Consistency assessment report

Proposed changes between Eaton Road, Luddenham
and Littlefields Road, Luddenham

**The Northern Road Upgrade – Mersey Road,
Bringelly to Glenmore Parkway, Glenmore Park**

December 2018

Figure 2-2 Comparison of SPIR/ Final EIS and refined construction footprints

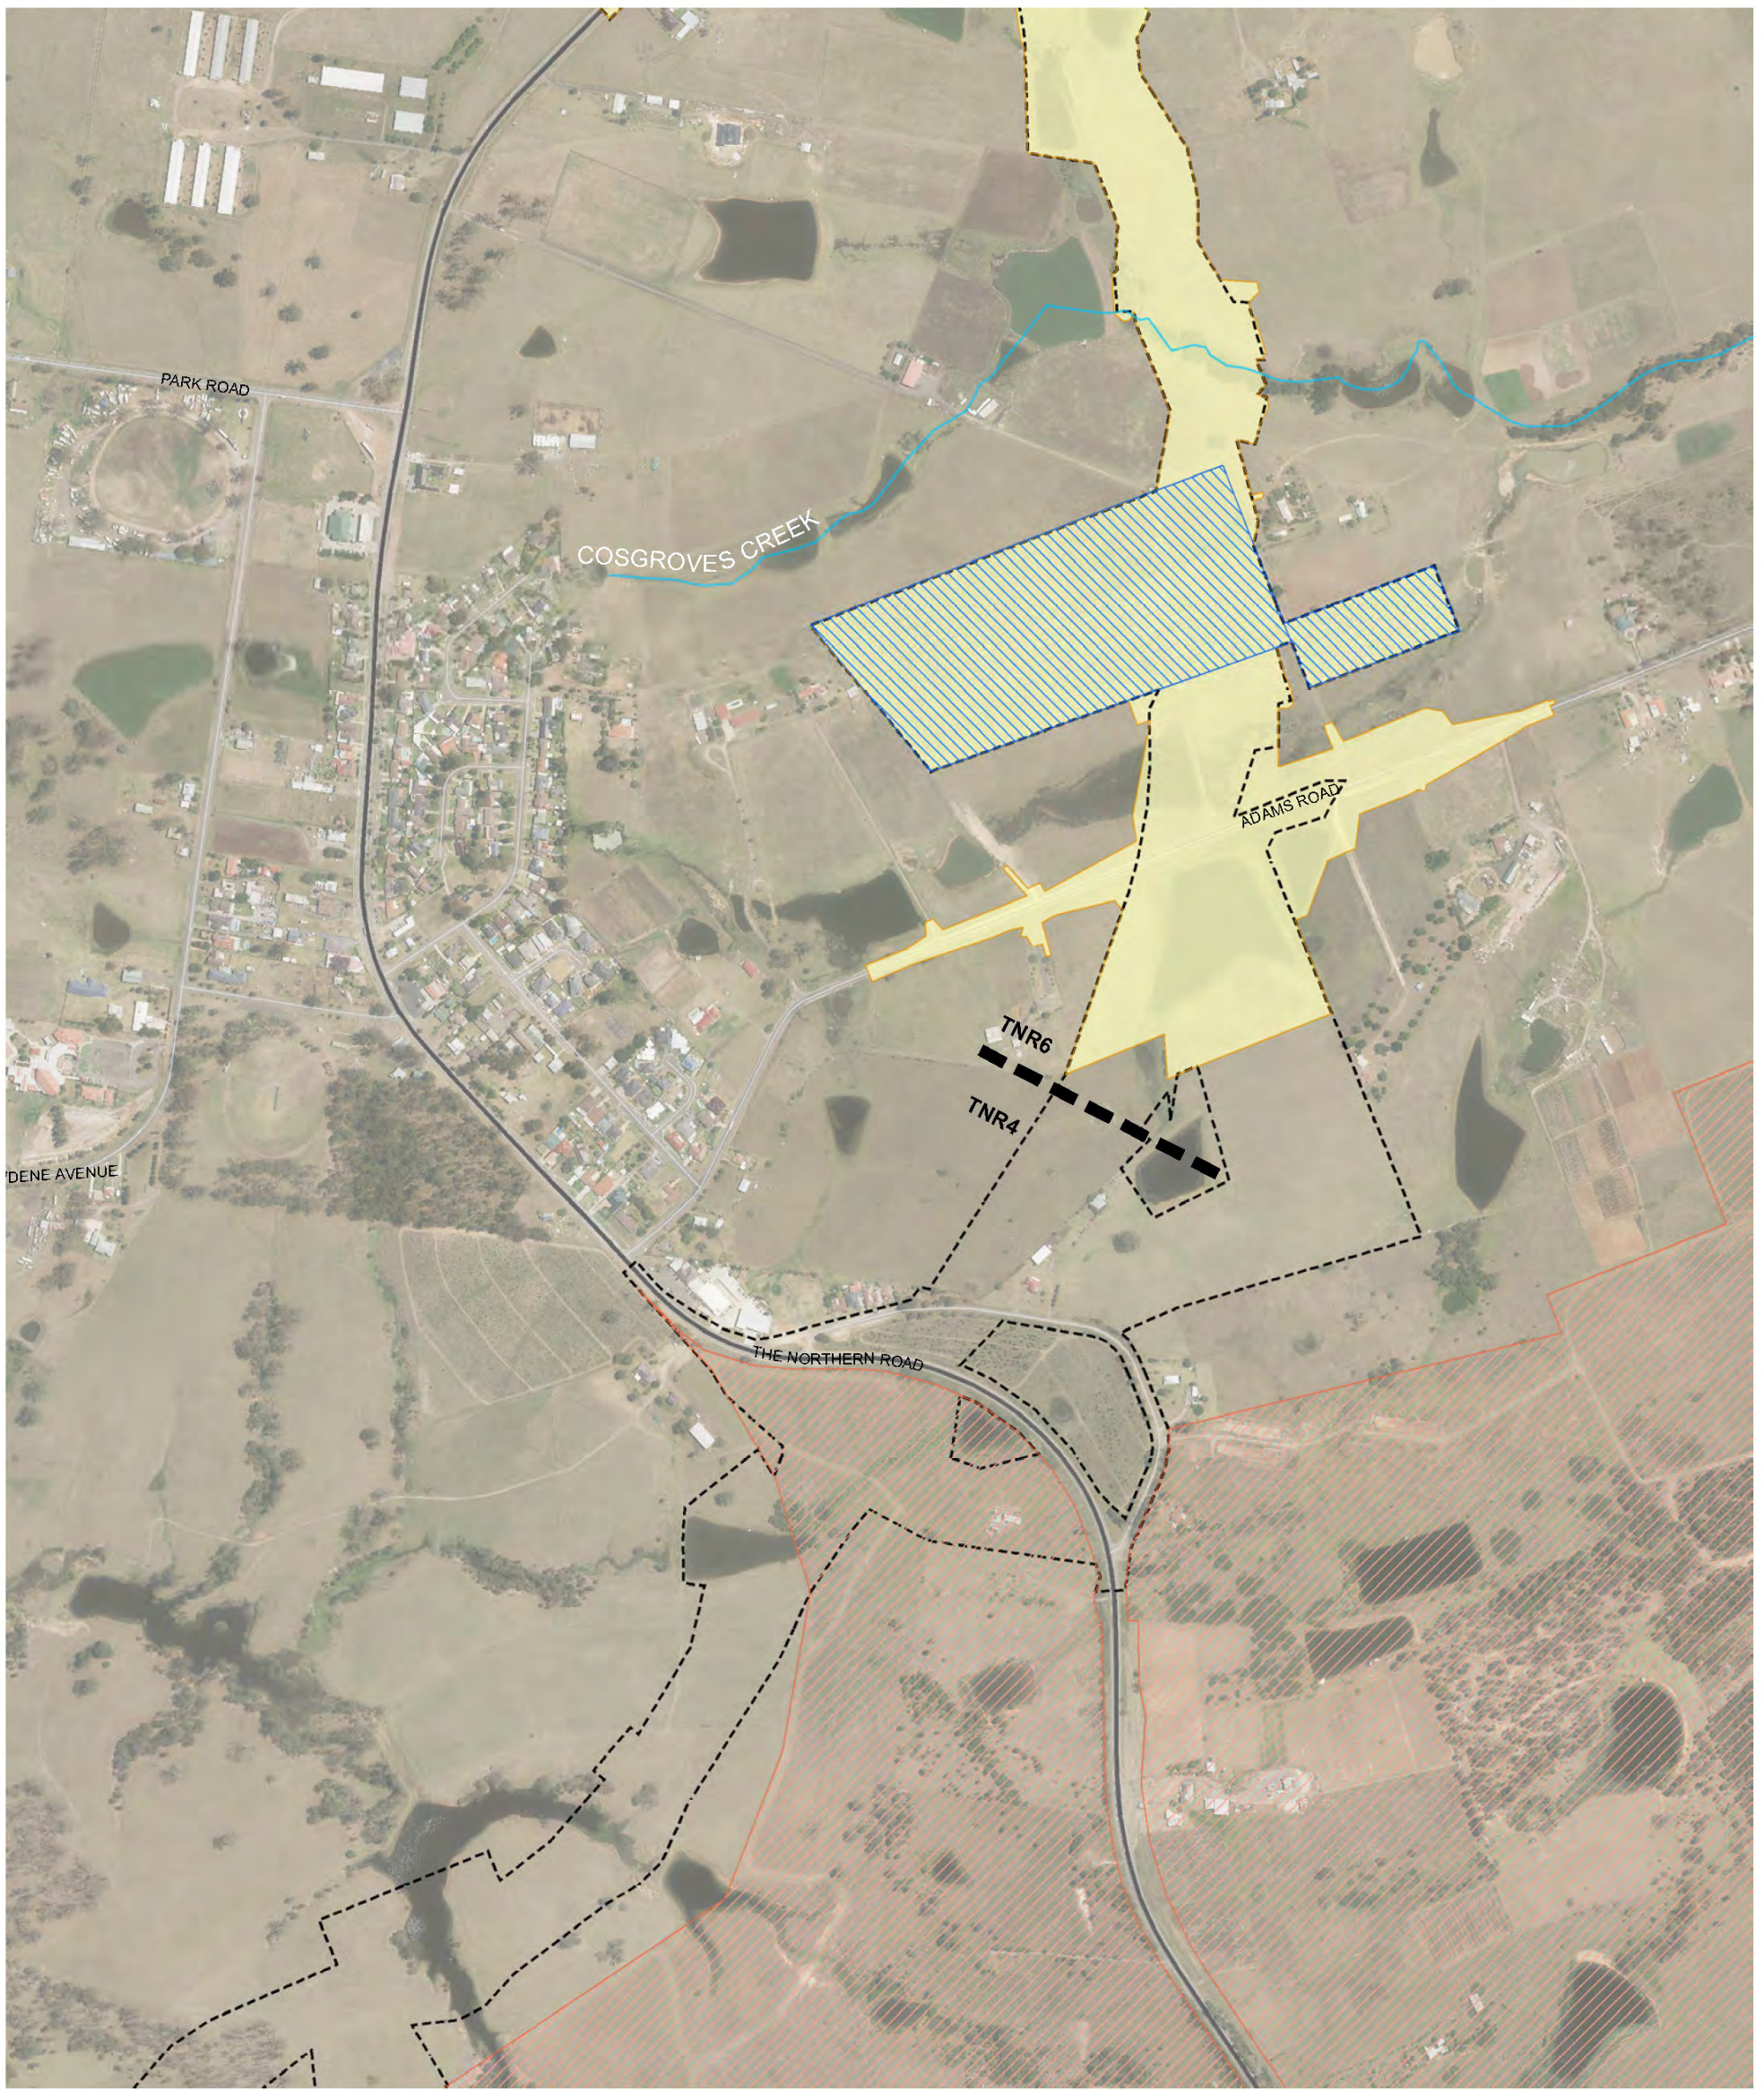
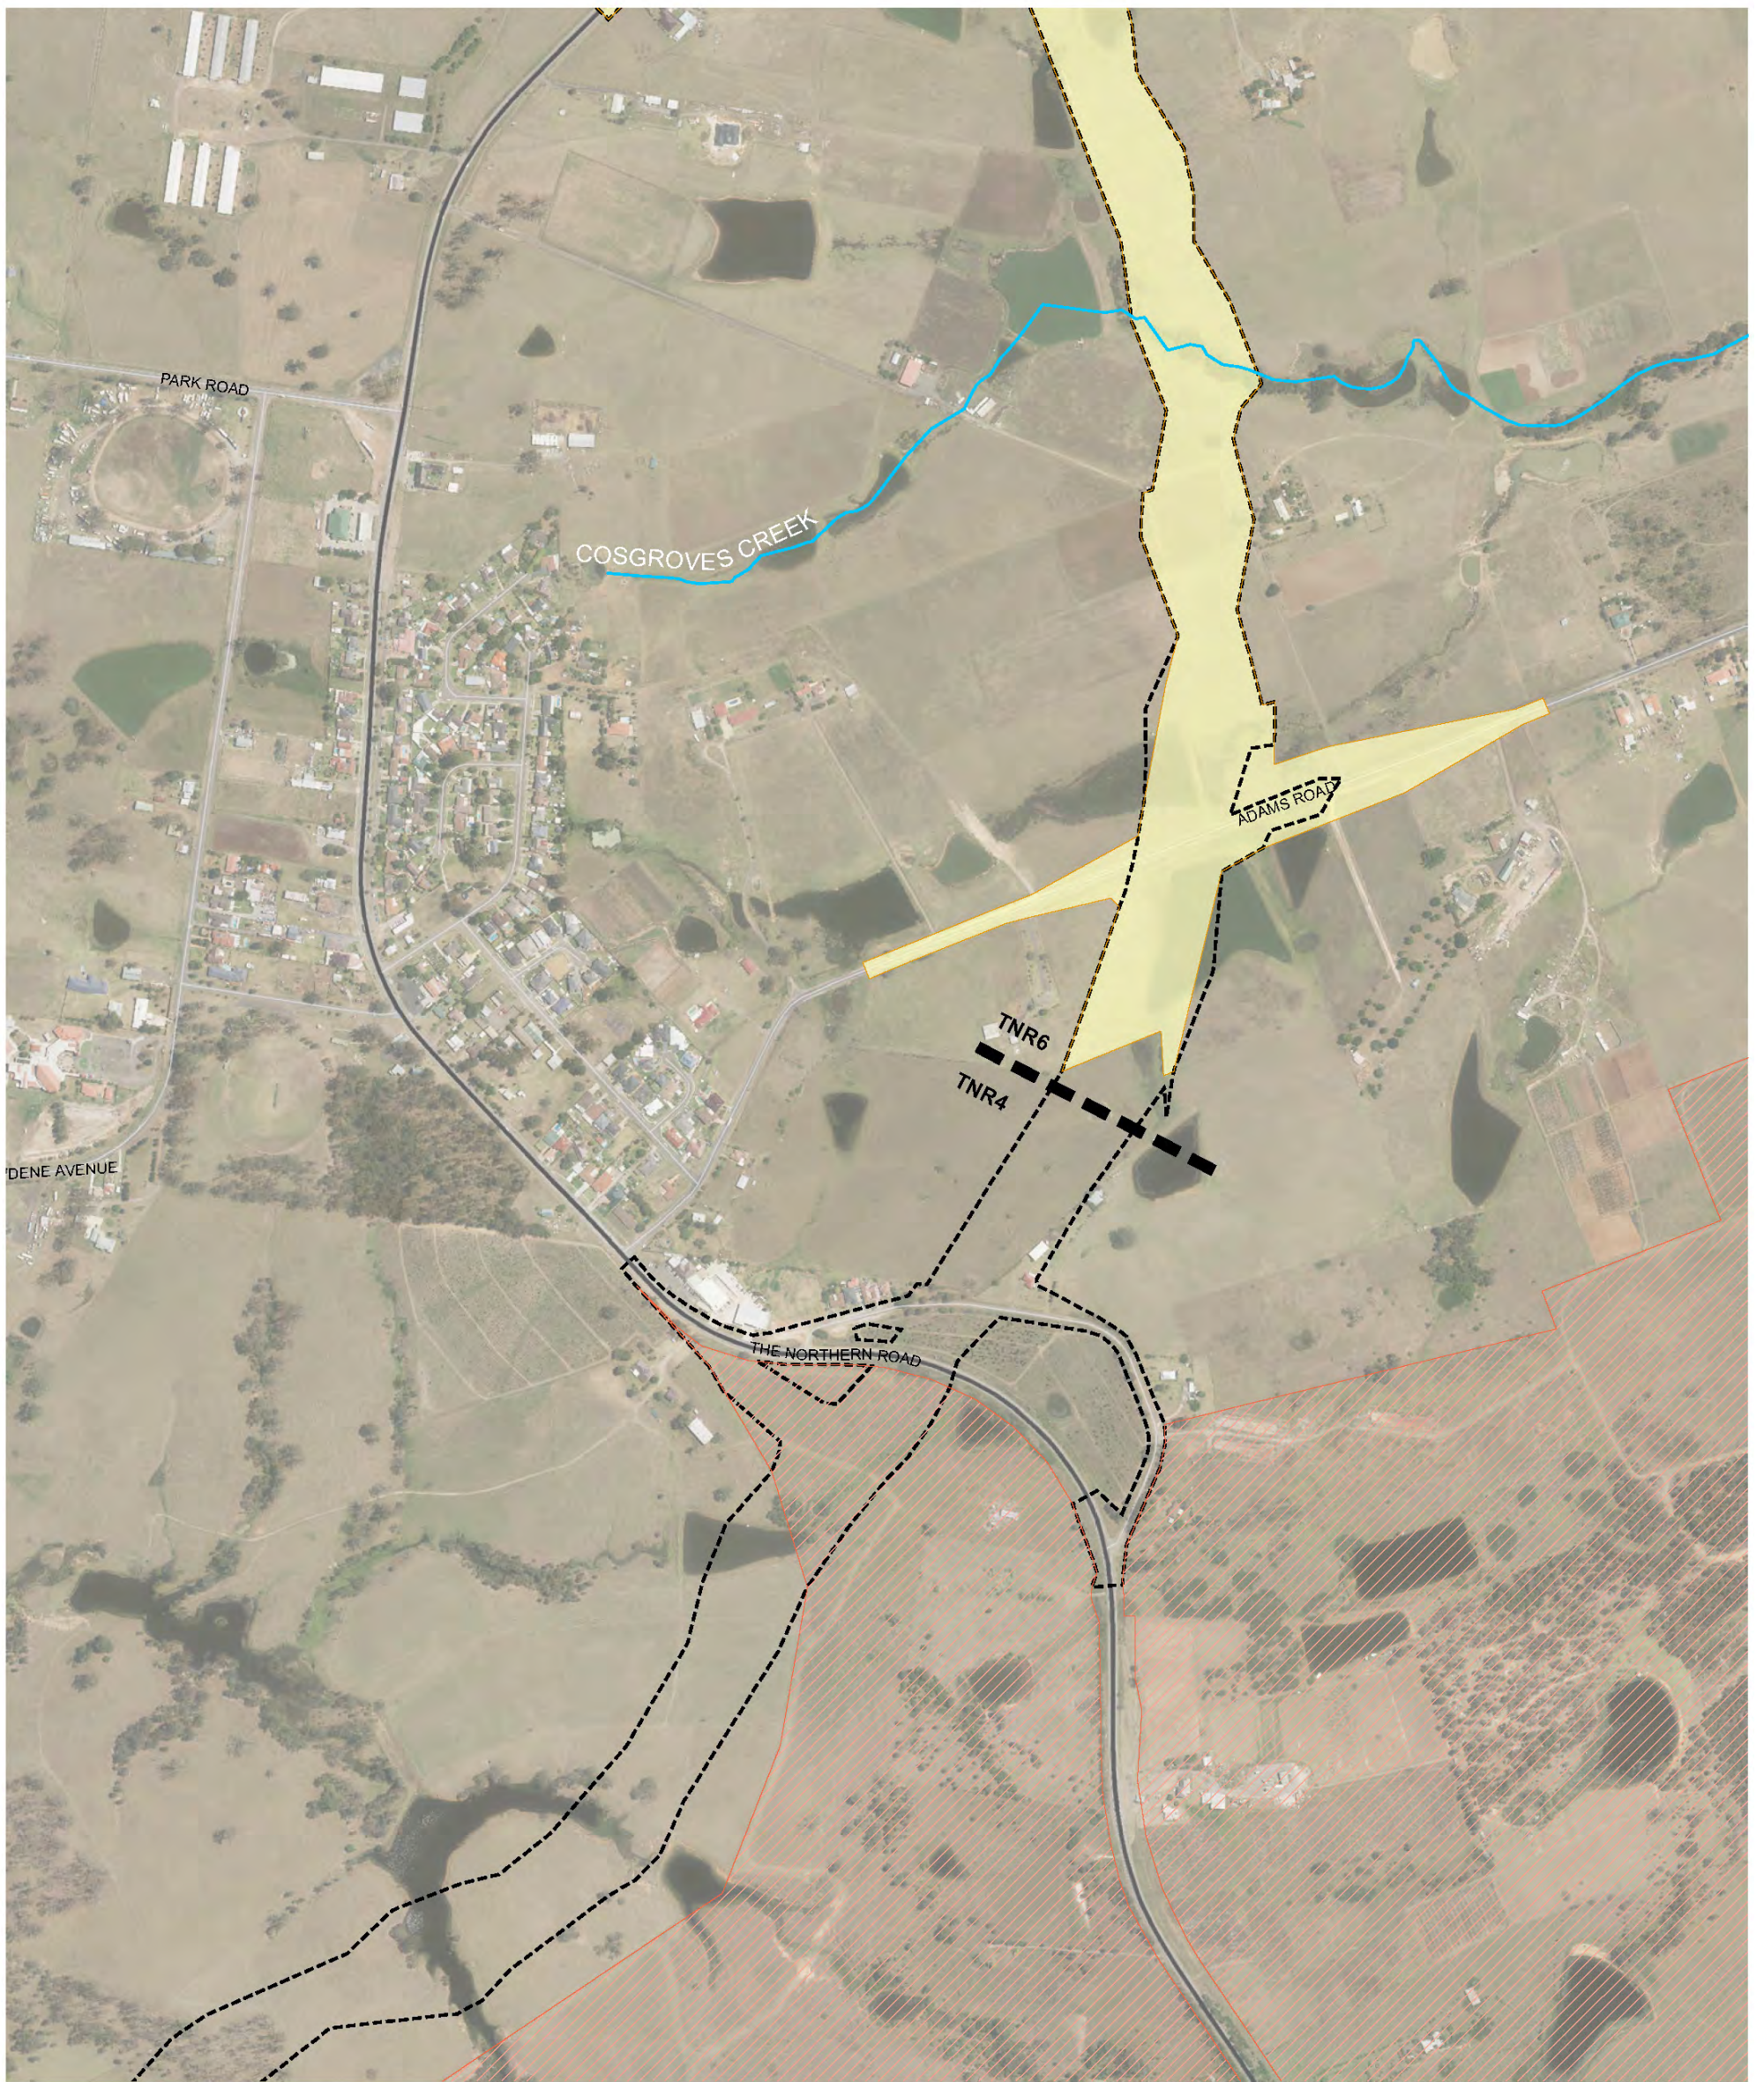
Proposed changes to the approved construction and operational project boundaries due to the proposed design changes are shown in Figure 2-2 and Figure 2-3 and are limited to:

- Minor increases to the construction boundary to allow private property access adjustments
- A reduced footprint for the ancillary facility area (and associated construction boundary) at the south-eastern corner of Elizabeth Drive and The Northern Road intersection
- Slight rationalisation (reduction) of the operational boundary at three locations based on the minor vertical, horizontal and cross-section alignment refinements proposed and consultation with affected property owners to reduce and simplify property acquisition.
- An increased construction and operational footprint around Adams Road to enable the regrading of this road (associated with the proposed modification).
